RE: **The Highlands**
Drainage Master Plan
Engineer's Stamp Date 6/28/17
Hydrology File: K15D034

Re: The Highlands / Hydrology File D15D034

HIGHLAND DEVELOPMENT OVERALL GRADING & DRAINAGE PLAN
EXISTING CONDITIONS

HIGHLAND DEVELOPMENT OVERALL GRADING & DRAINAGE PLAN
PROPOSED GRADING & DRAINAGE

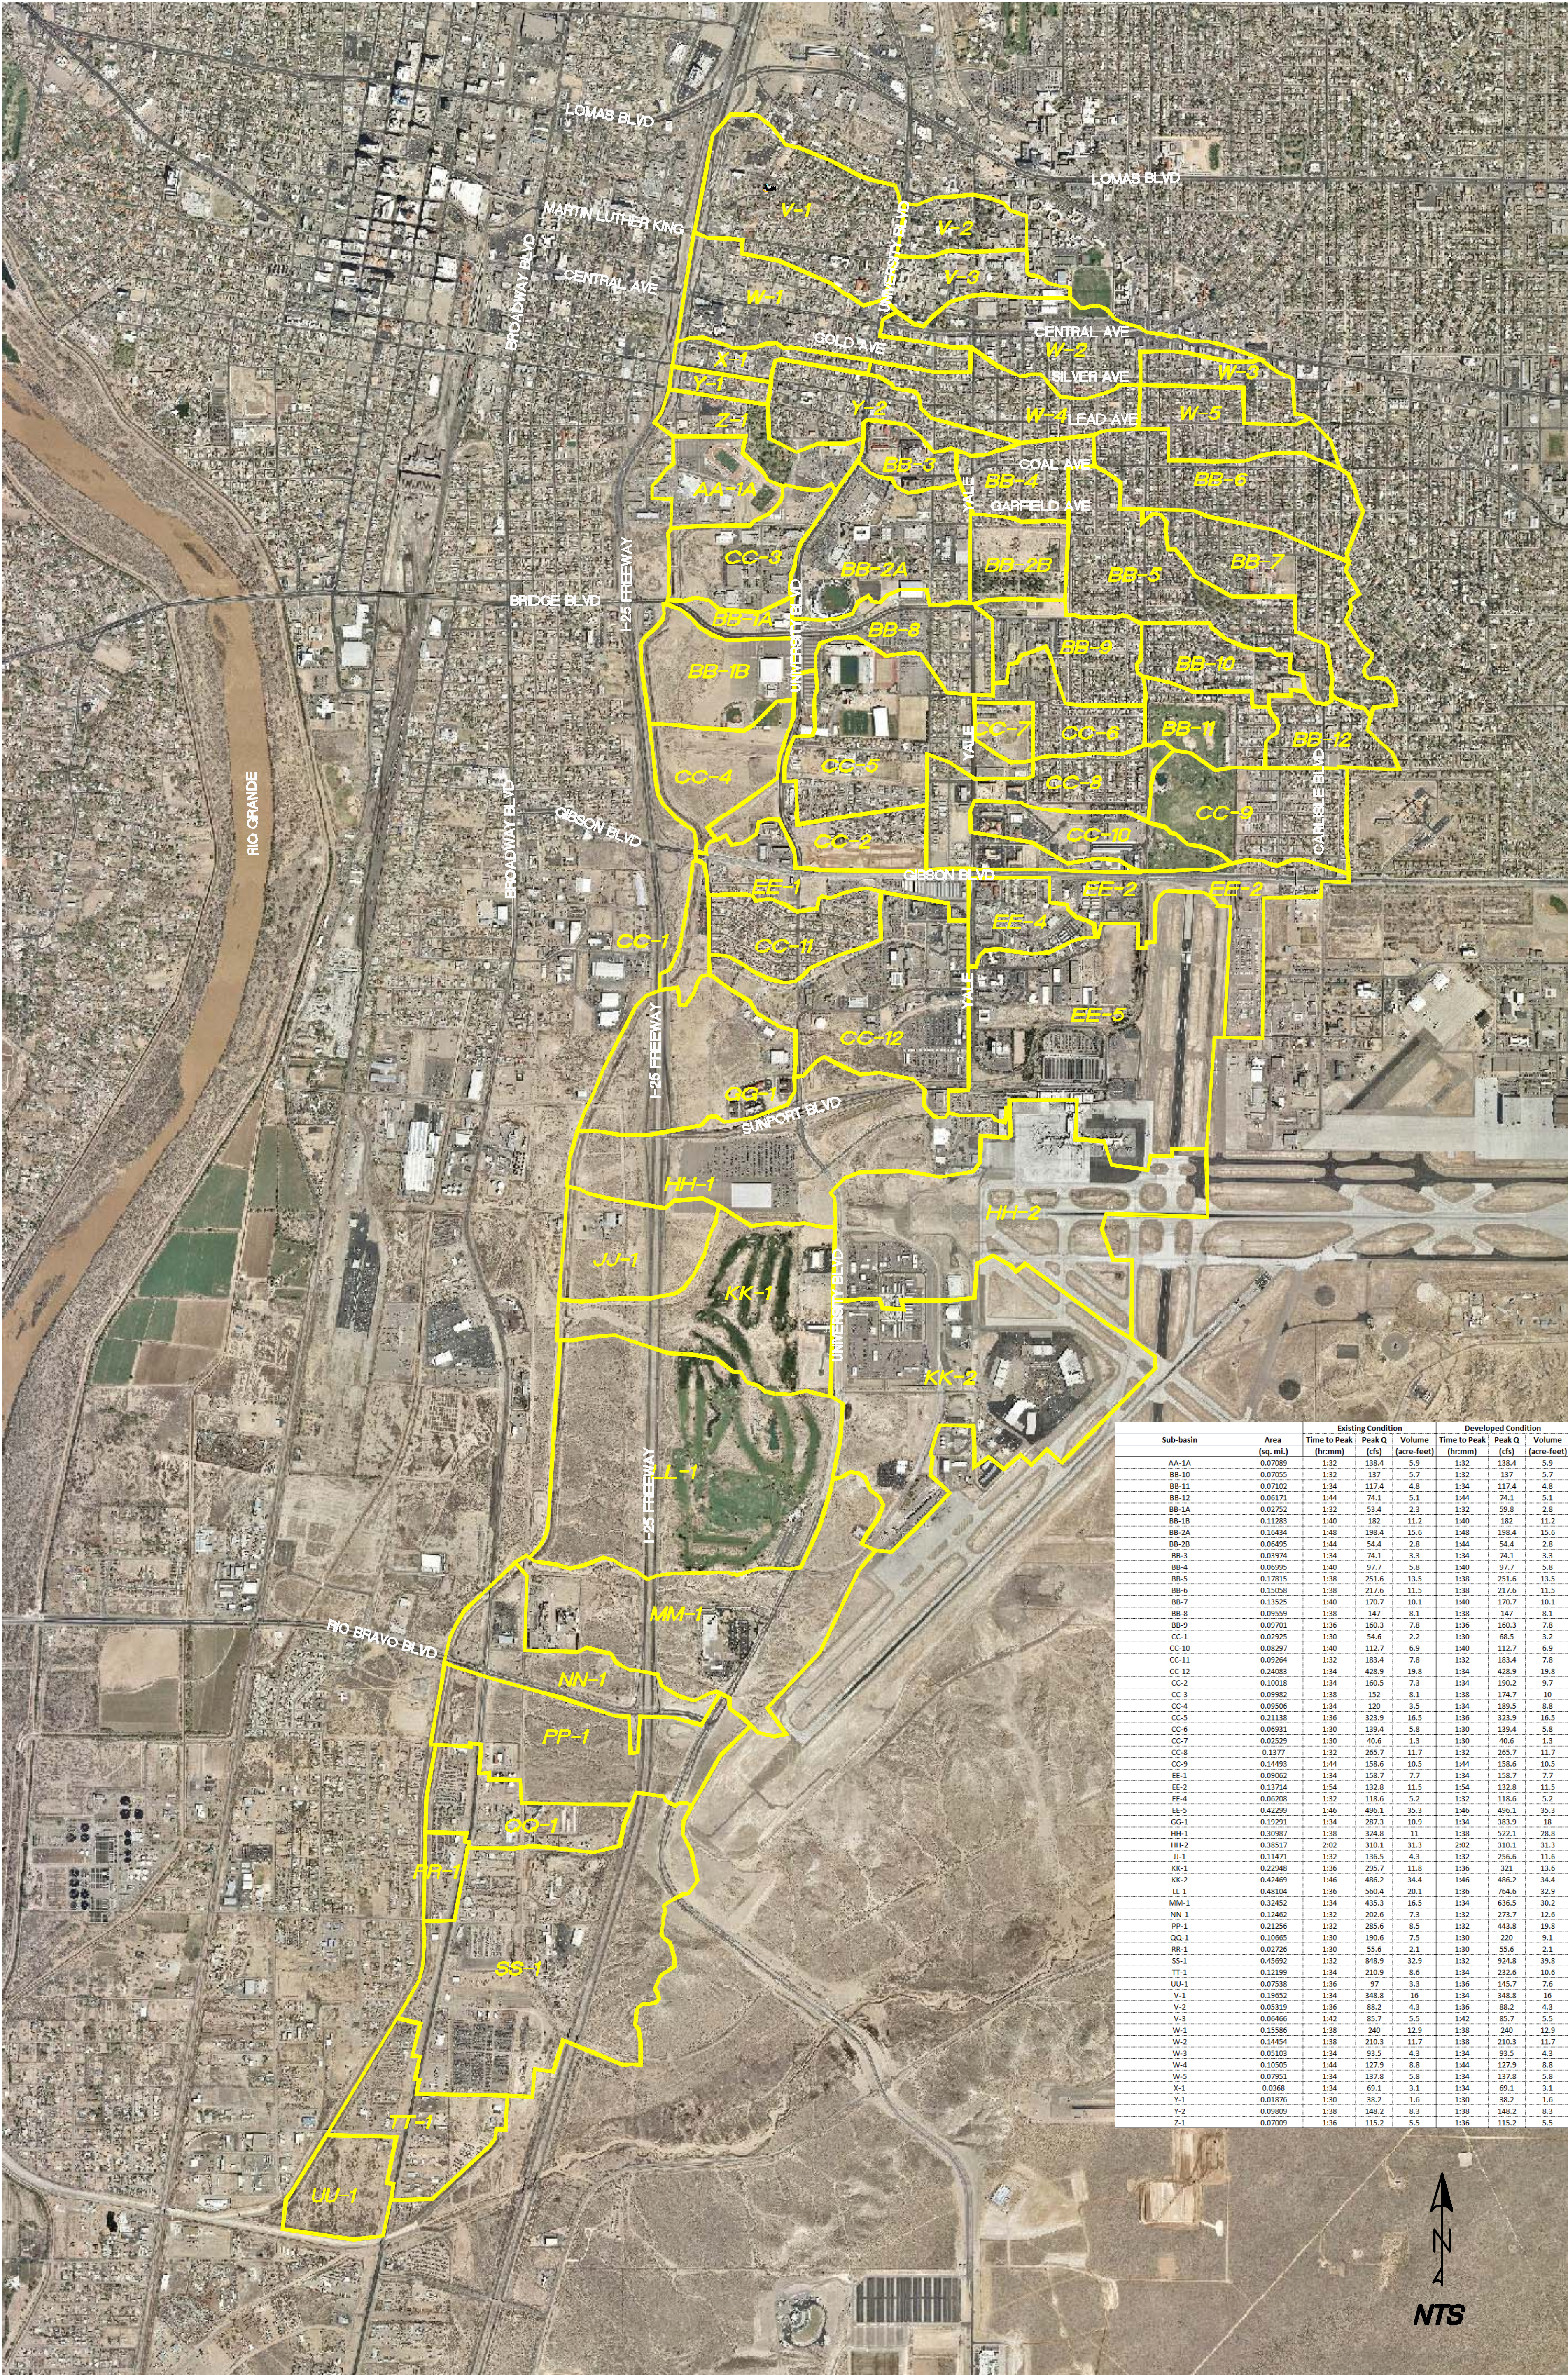
1. The hydrology analysis is incomplete. Upstream offsite basins from the UNM campus are missing from the hydrology, and additional basins along Central should also be considered in the determination of the peak flow in the existing downstream storm drain in Cedar.

2. A more detailed analysis of the Cedar storm drain HGL may find that the existing storm drain has adequate capacity for the increased flows from this development. However if the analysis shows the Cedar storm drain does not have adequate downstream capacity, then on-site (privately maintained) detention ponds will be necessary to limit post-development 100-year peak flow rates to those of pre-development. Increased flows to over-capacity systems cannot be authorized by the City Engineer in accordance with § 14-5-2-12 (G) of the Albuquerque Code of Ordinances.

3. HGL calculations will be required for all new storm drain connections to the existing lines and should start with a reasonable approximation of the HGL in the existing storm drains. Where the existing storm drains are over capacity the HGL may be a little above the existing surface as long as MH lids are bolted. Place new inlets where they are higher than the HGL of the Pipe that they are connecting to. Inlets connecting to the Cedar Pipe should be higher than the surface elevation in the intersection of Cedar/Copper.

4. Analysis of downstream capacity needs to continue to a reasonable point of analysis. For the Cedar storm drain, this must incorporate the 72" storm drain under Central and continue south of Central.
5. Downstream capacity and historic flow rates must be analyzed at each proposed discharge location; this includes each discharge location along the western edge of the site.
6. Proposed flows must be provided for each analysis point departing your site, not just the change in flow.
7. For exhibit B, include AHYMO input and output files and provide detailed methodology and assumptions.
8. In exhibits A and B, what happens to subbasins V-2 and V-3? These both route into Basin V-1 and need to be included in the analysis.
9. Analysis of existing developed conditions needs to be based on Table A-5, Ch 22.2 (A) of the DPM for determining percent impervious.

6. The Master Grading Plan should include onsite floor elevations and flow arrows to indicate onsite private drainage basins and all points of discharge into public drainage infrastructure.

Response: Please see the Proposed Grading & Drainage Plan.
